# LARSON RIVER ROAD AUTO STORAGE

**PERMIT SET**

**COVER SHEET**

Sheet No.  
**C1.0**  
2 of 12 Sheets

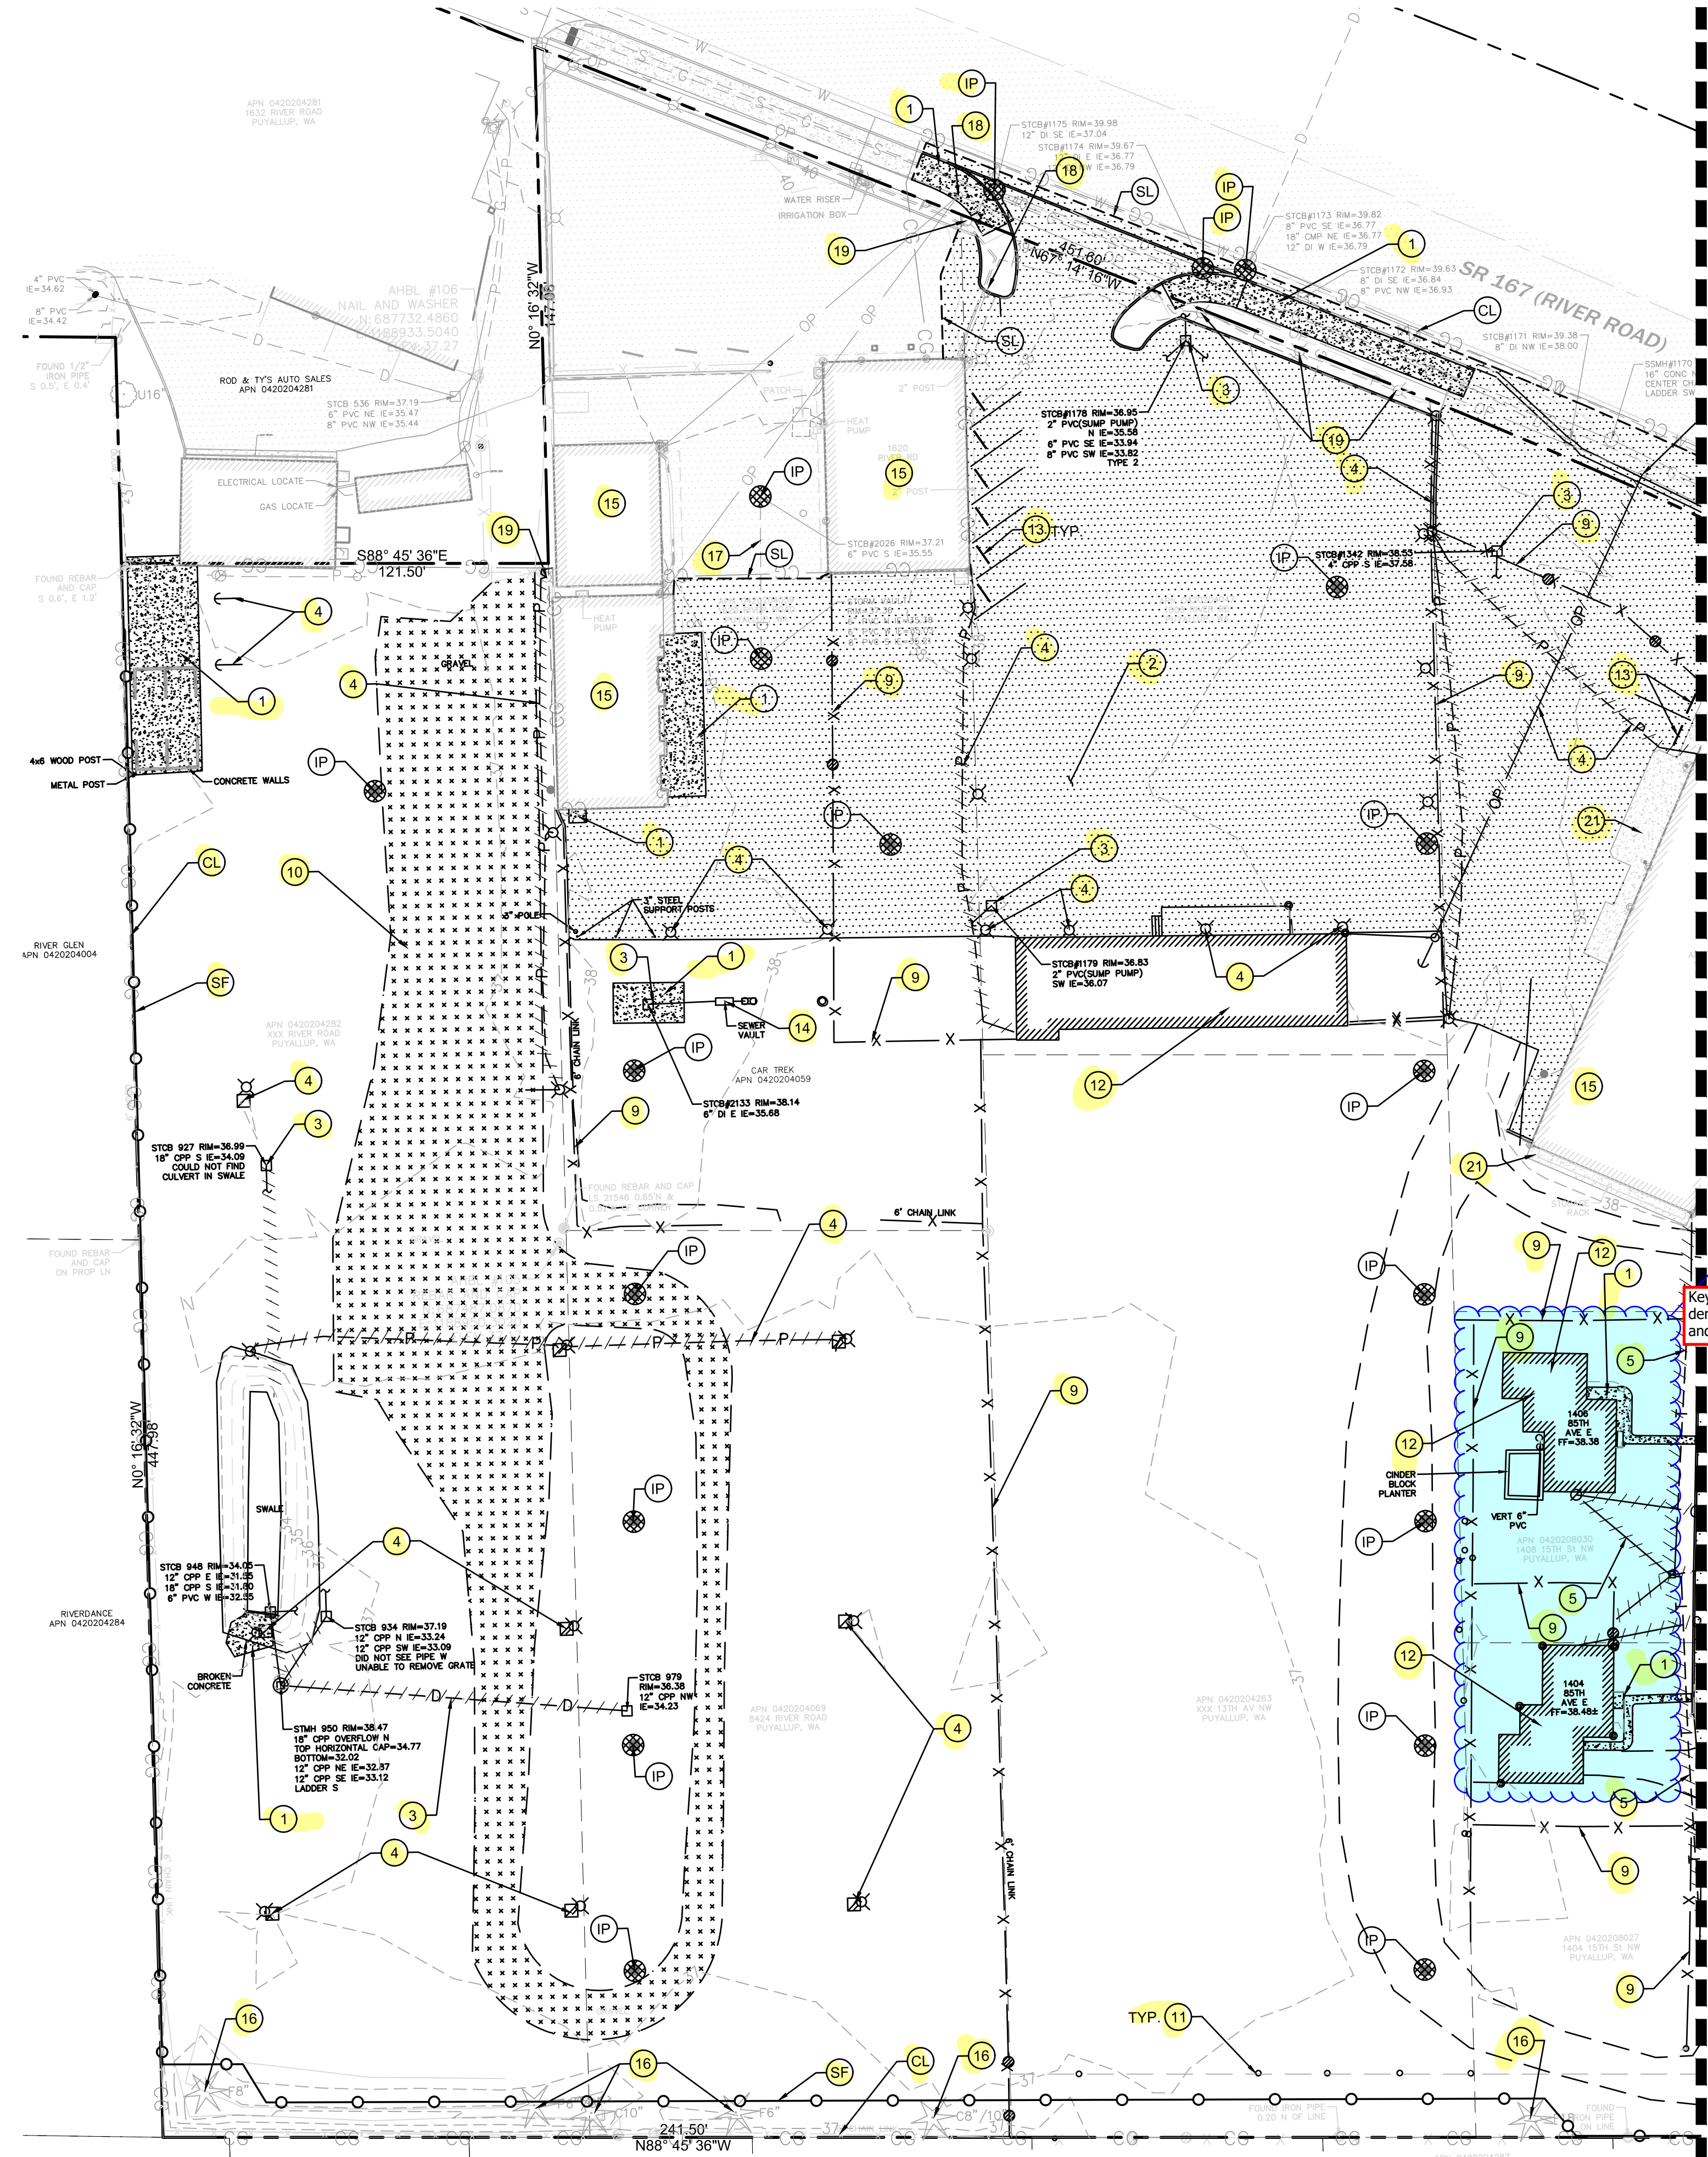
See comments on Sheet C1.1  
Keynote 22 added for demolishing water services and capping at main.

Sheet No.  
**C1.1**  
3 of 12 Sheets

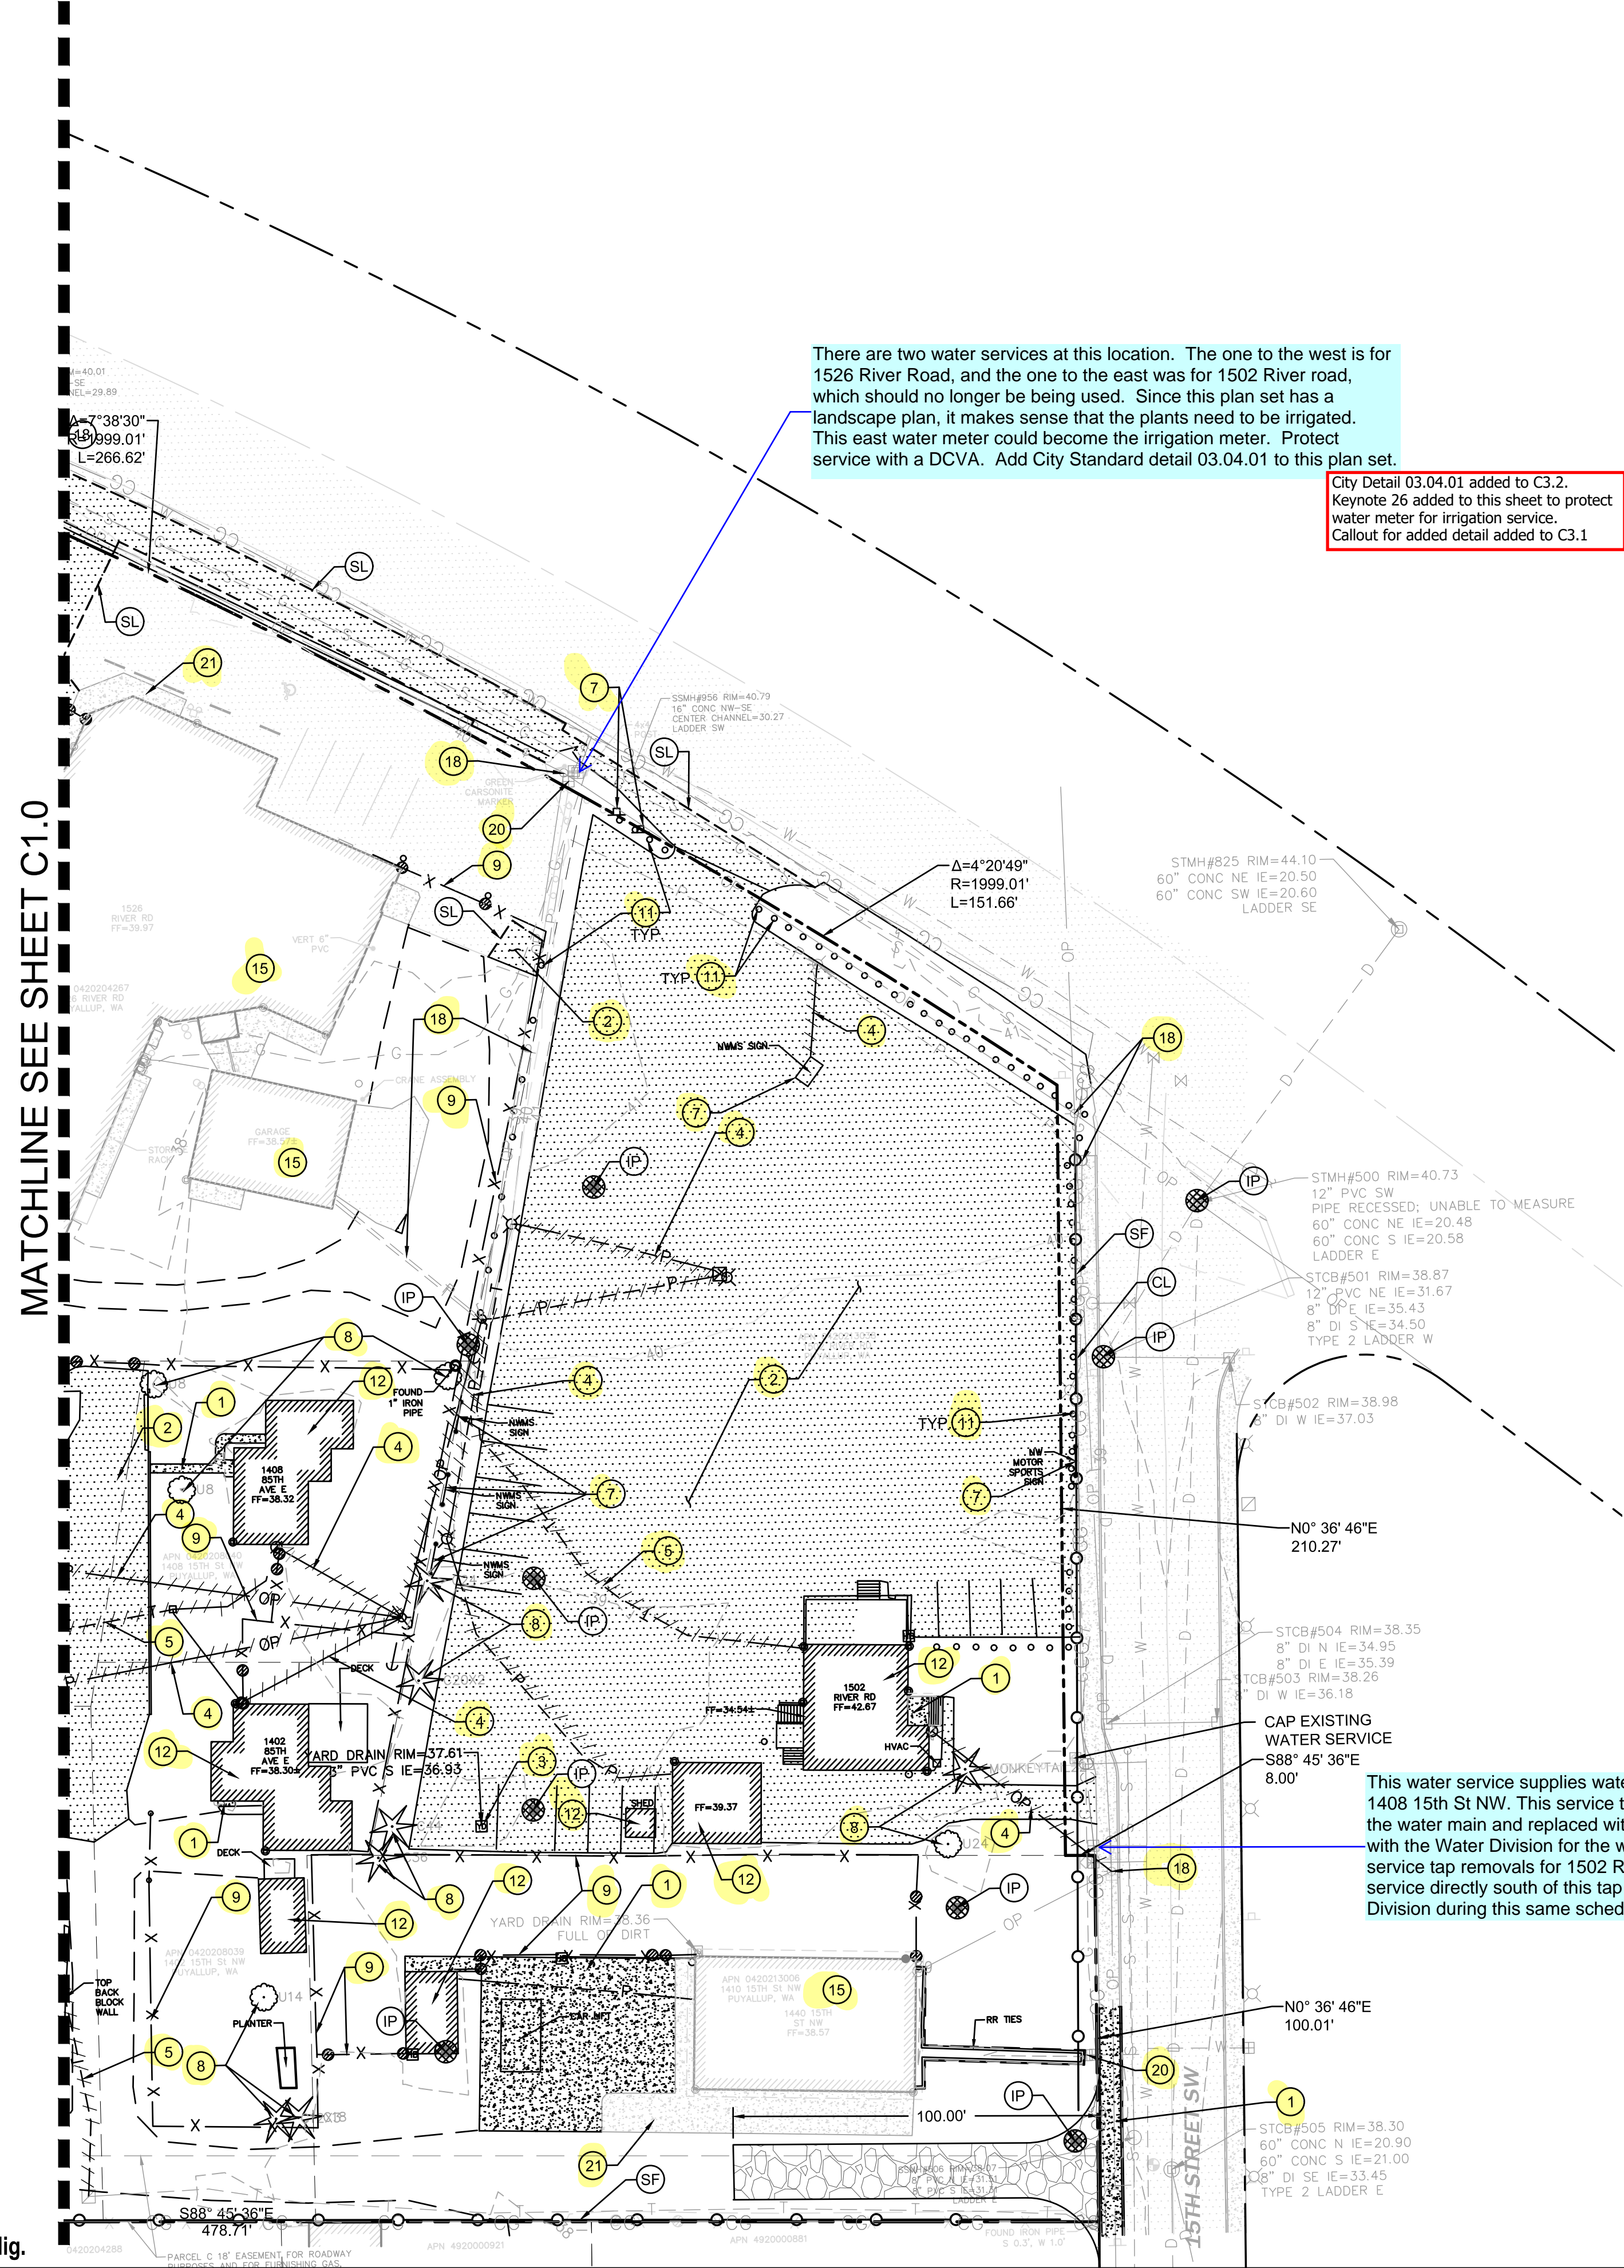
There are two water services at this location. The one to the west is for 1526 River Road, and the one to the east was for 1502 River road, which should no longer be being used. Since this plan set has a landscape plan, it makes sense that the plants need to be irrigated. This east water meter could become the irrigation meter. Protect service with a DCVA. Add City Standard detail 03.04.01 to this plan set.

This water service supplies water to 1402, 1404, 1406, and 1408 15th St NW. This service tap needs to be removed from the water main and replaced with a brass plug. Coordinate with the Water Division for the water main shutdown. The service tap removals for 1502 River Road and for the water service directly south of this tap will be done by the Water Division during this same scheduled water main shutdown.

City Detail 03.04.01 added to C3.2.  
Keynote 26 added to this sheet to protect water meter for irrigation service.  
Callout for added detail added to C3.1

Keynote 22 added for demolishing water services and capping at main. note that a fire hydrant was added at the SW of the site and connection to main was shown at this location.

**C3.2**  
8 of 12 Sheets

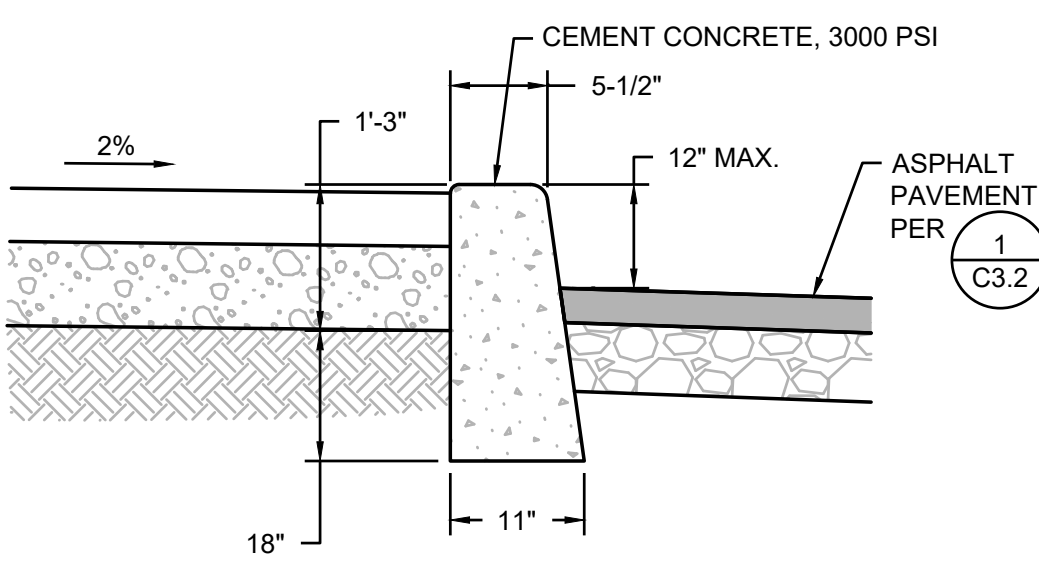
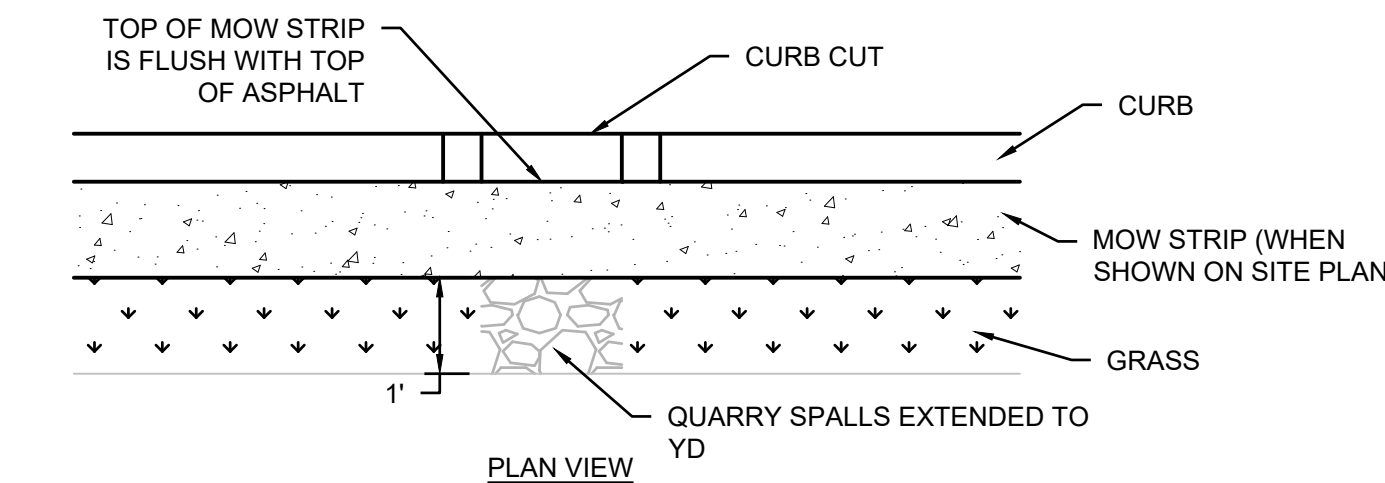
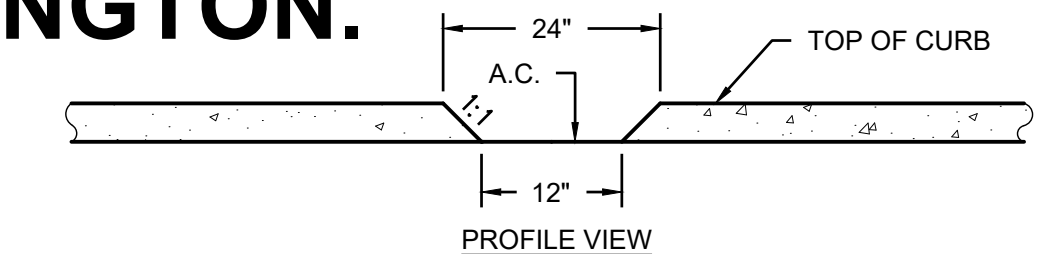
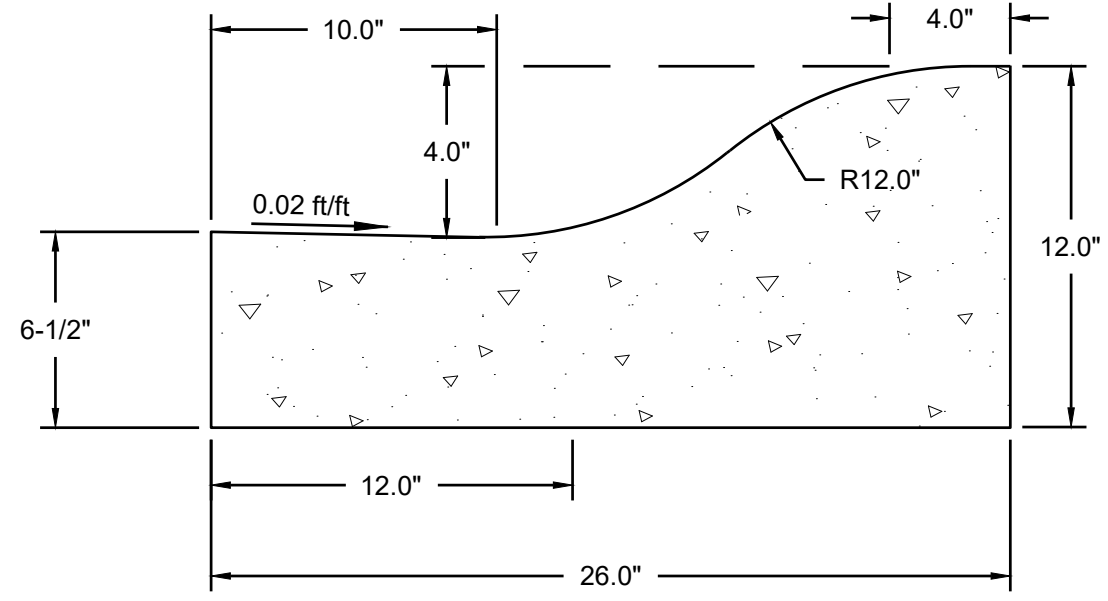
Storm Site Plan and SWPPP references seven 18" cartridges. Clarify.

Sheet C3.1 lists outlet pipe at an elevation of 25.17. Clarify.

This detail updated to be baysaver. SWPP updated to correspond. 6-45 gpm cartridges handlers 0.6 cfs wq flows this covers the modeled 0.51 cfs wq flow
